DESIGN ADVISORY BOARD Tuesday, January 27, 2015 at 3:00 PM Conference Room 12, City Hall, Burlington, VT

TO: Design Advisory Board
FROM: Scott Gustin
DATE: January 27, 2015
RE: 14-0734CA/CU, 502 North Street

Request: Rear addition to home, driveway expansion, and creation of accessory apartment.

DODSON RESIDENCE
502 NORTH STREET
DESIGN ADVISORY BOARD SUBMISSION
JANUARY 14, 2015

2 PROPOSED LOT COVERAGE

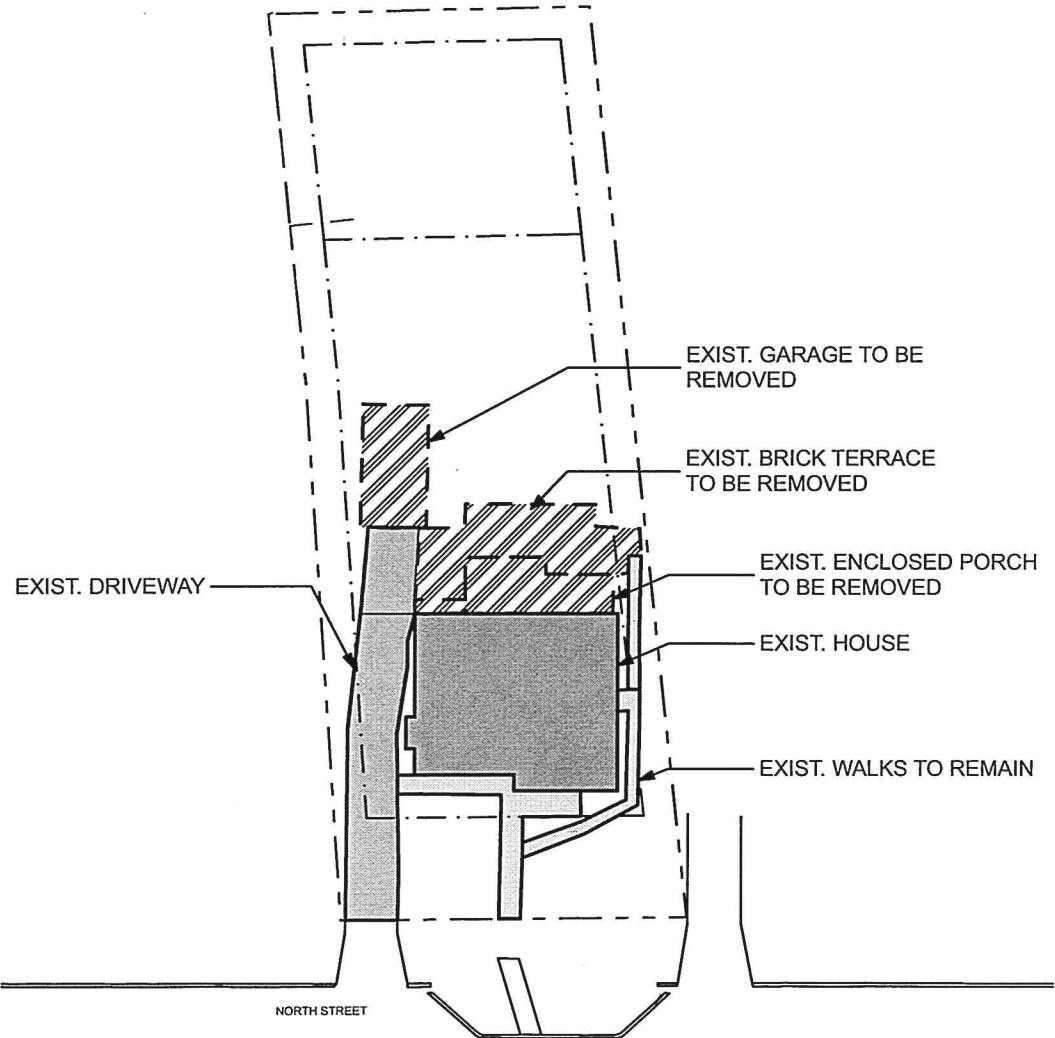
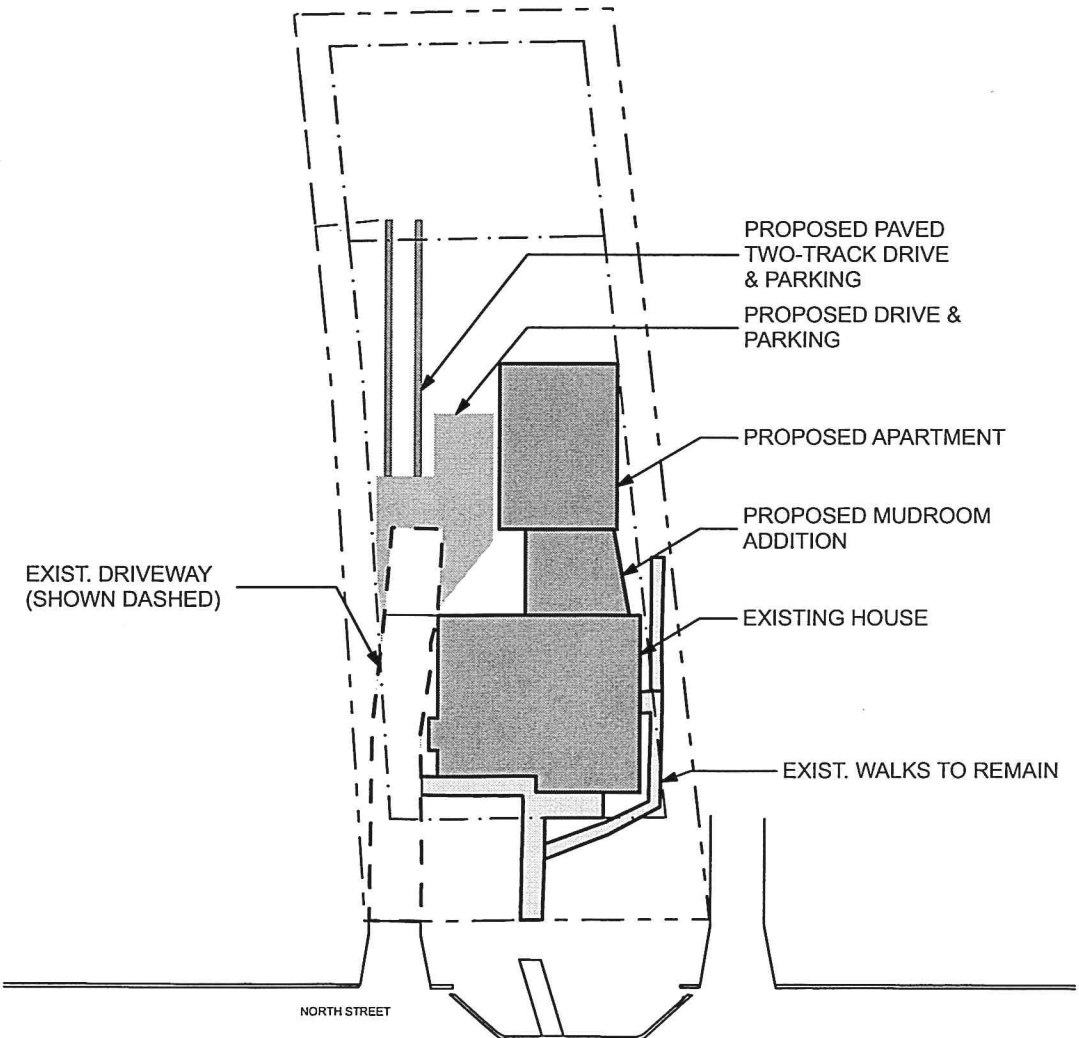
Although lot coverage is not addressed under Article 6, it bears noting that staff's calculation of new driveway lot coverage differs from that of the applicant's. Staff calculates an additional 453 sf of new driveway coverage. This figure includes two 9' X 20' parking spaces over the new driveway strips in addition to the additional area for the apartment parking space and some incidental new driveway area associated with the reconfiguration. The application notes just 403 sf of new driveway lot coverage. This 50 sf discrepancy, while small, needs to be rectified.

1. Rectify the 50 sf driveway lot coverage discrepancy between staff's and applicant's calculations.
2. Provide walkway connecting apartment doorway to apartment parking space.

Regarding the noted discrepancy between staff's calculations and the submitted calculations of lot coverage: The lot coverage submitted has been calculated using a precise computer drafting and modeling program incorporating the topographical property survey. The existing and proposed lot coverage diagrams have been revised to illustrate the specific area values used for calculating lot coverage. It is worth noting that after clarification from Scott Gustin, the lot coverage calculations have additionally been revised to incorporate the entire allotted area of the 2 new tandem parking spaces, despite the fact that they are comprised only of two-track gravel materials. Further revisions also take into account the changes in lot coverage resulting from the replacement of the existing driveway with the new two-track driveway. A meeting has been scheduled with Scott Gustin to review and identify the source of the discrepancy in calculations.

1 SOUTH ELEVATION (AT NORTH STREET)
SCALE: 3/16"=1'-0"

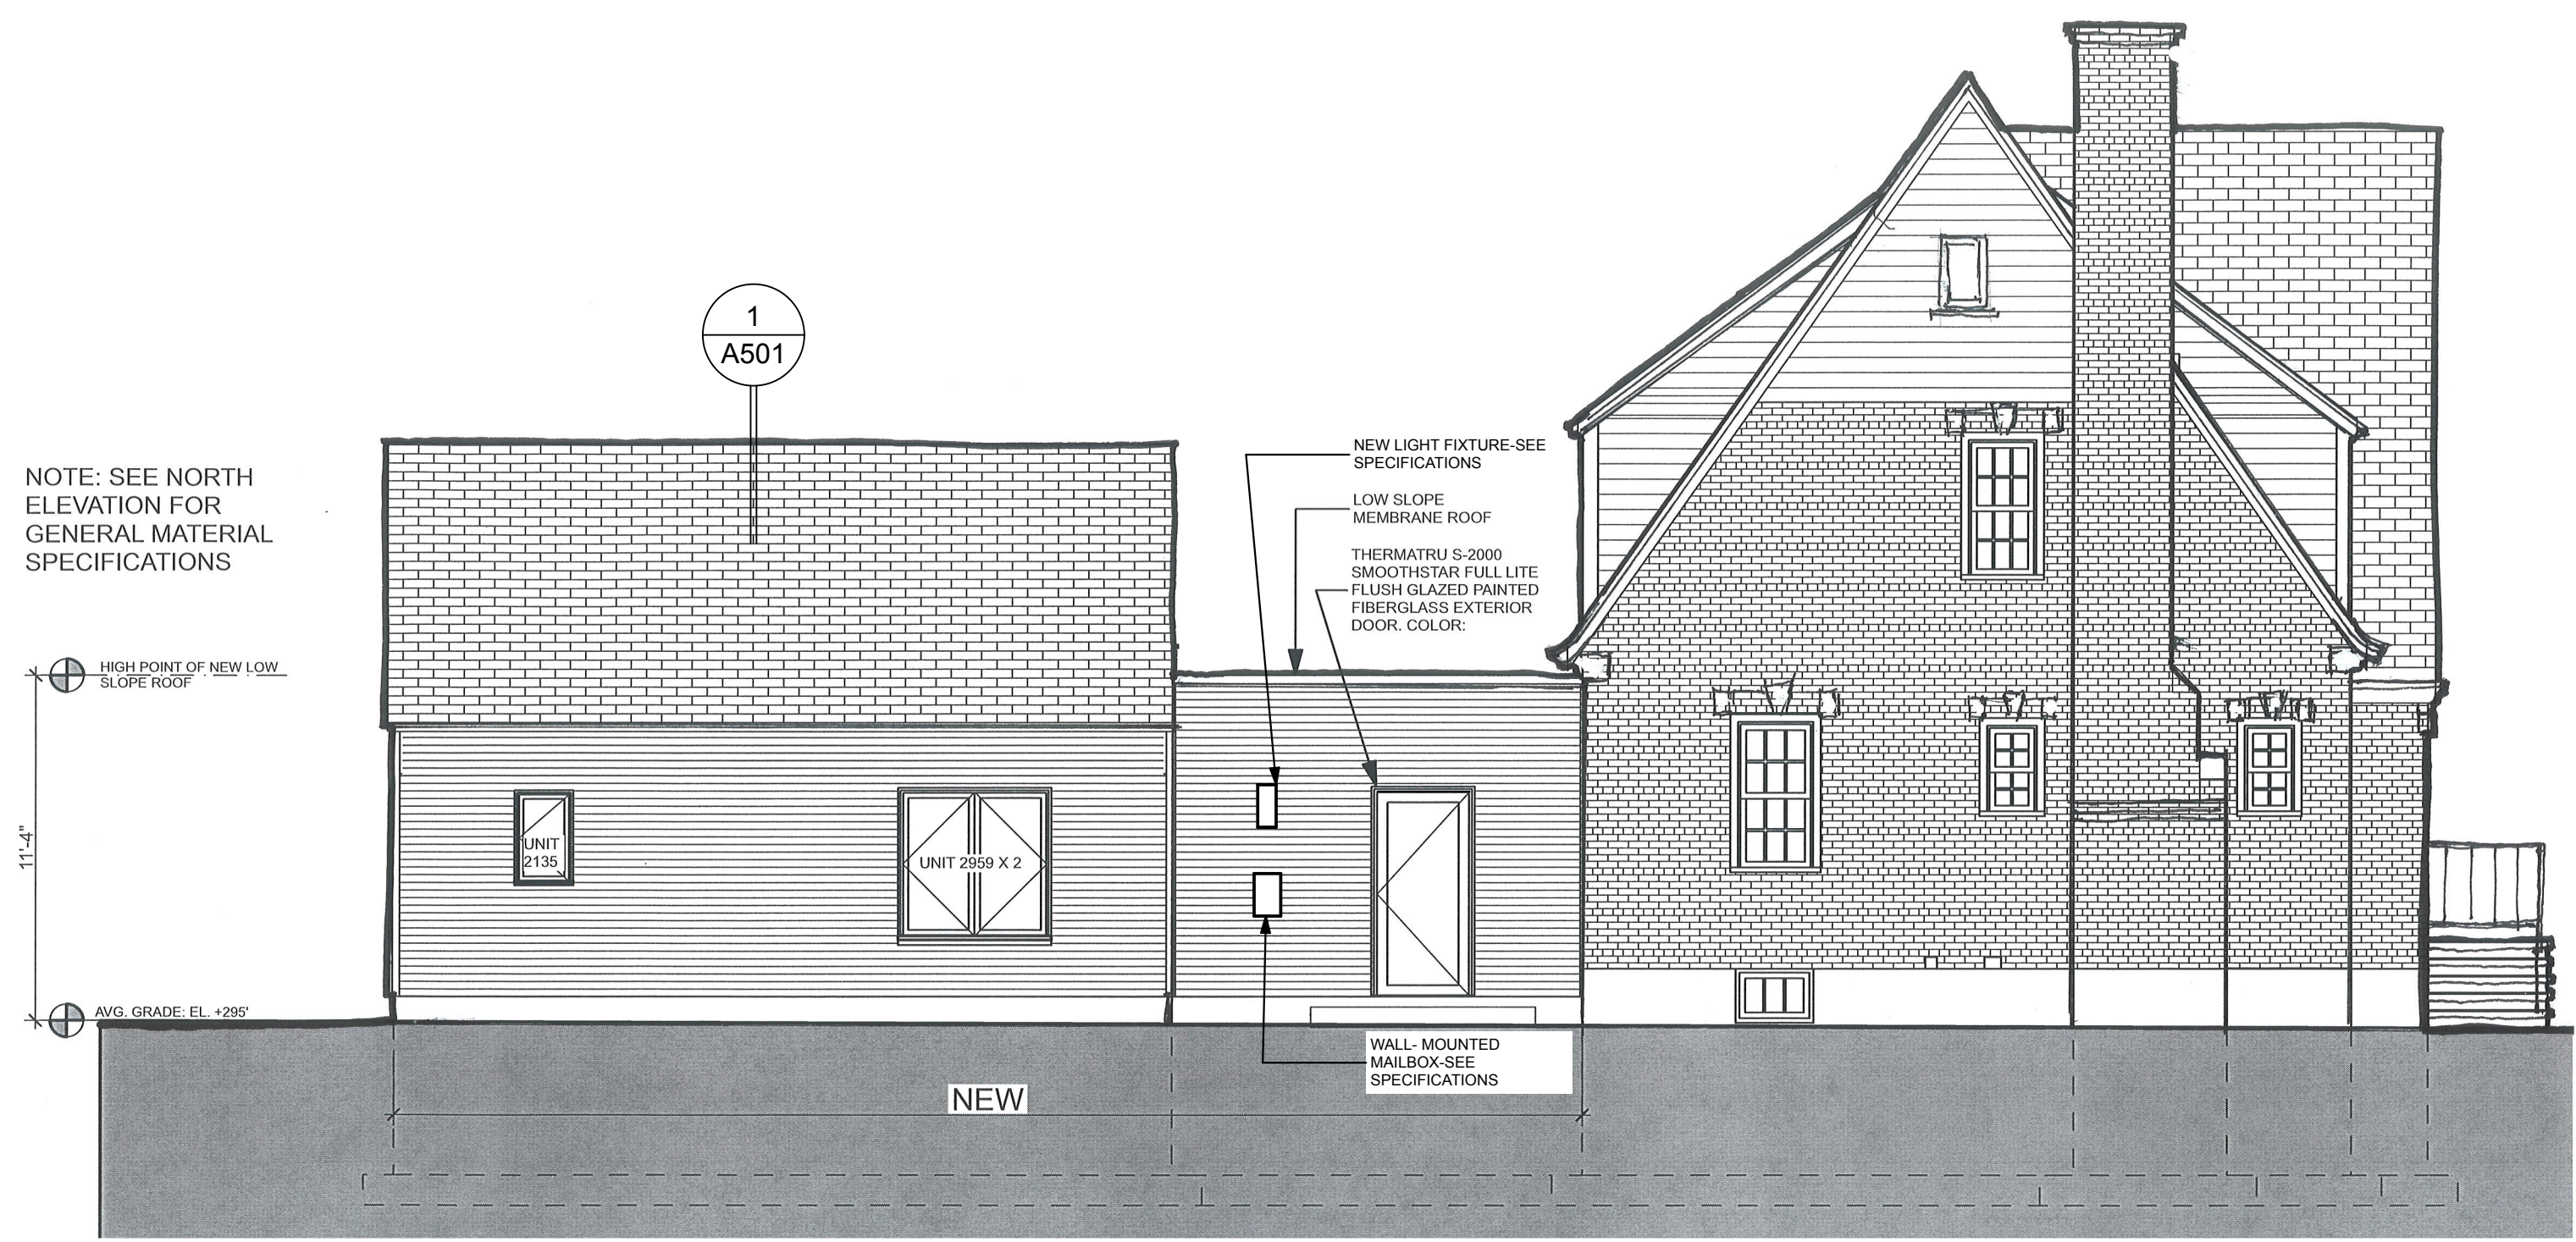
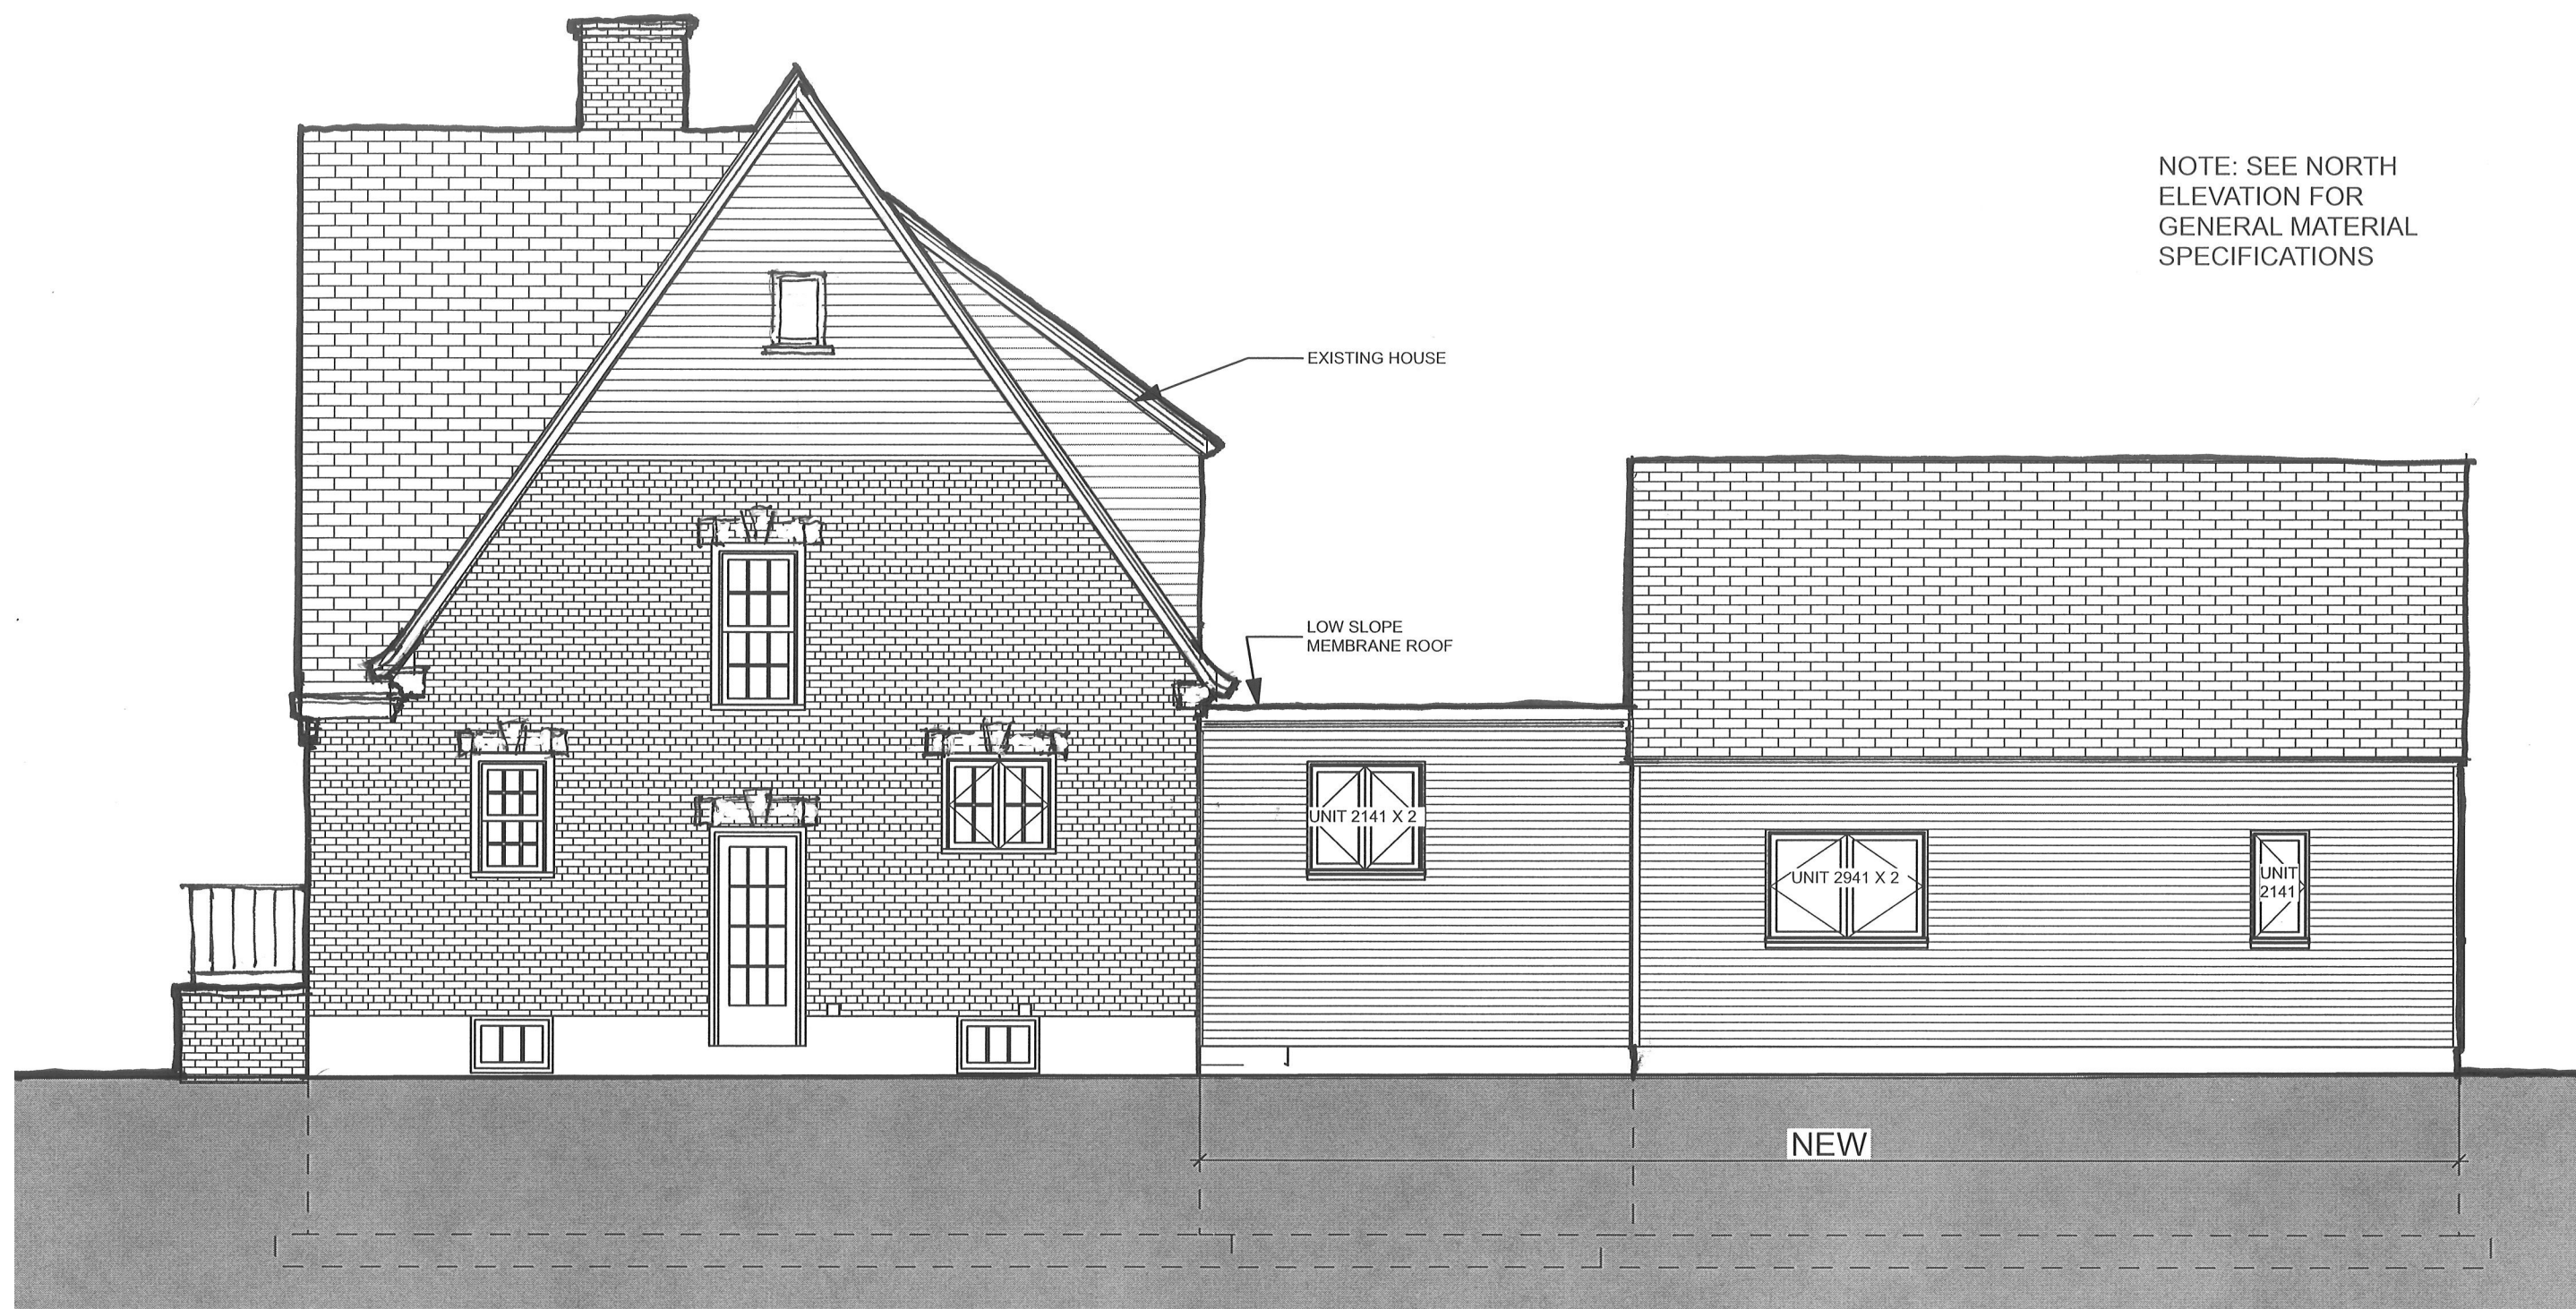
No outdoor lighting information has been provided and must be. Presumably, at least the new doorways in the proposed addition and apartment will be illuminated. Fixture cut sheets and locations need to be specified.

No changes are proposed to the front entry of the historic home. As for the addition, the mudroom will have a doorway facing the driveway, and the apartment will have an entrance facing the back yard. This rear-facing orientation is acceptable as a rear addition. Single-lite casement windows are proposed in the mudroom and apartment, and full-lite exterior doors will be installed. The mudroom and apartment addition may, and should, clearly differ from the original home. Both do so; however, the windows are an opportunity to provide some tie-in between the original and new construction. As proposed, there is no relationship between windows in the original home and the new construction. Proportions of windows, whether ganged or single, should mimic those in the existing home. Likewise, windows in the new

construction should match the style of those in the existing home (i.e. simulated double hung units of either six-over-six or two-over-two appearance). Muntins and the dividing bar should be factory-adhered to the exterior of the new casement units.

New light fixtures will be provided to illuminate both the entrance door at the proposed Mudroom and also the sliding doors on the north side of the new apartment. The exterior elevations have been revised to show proposed fixture locations. Fixture cut sheets have also been provided as part of this addendum.
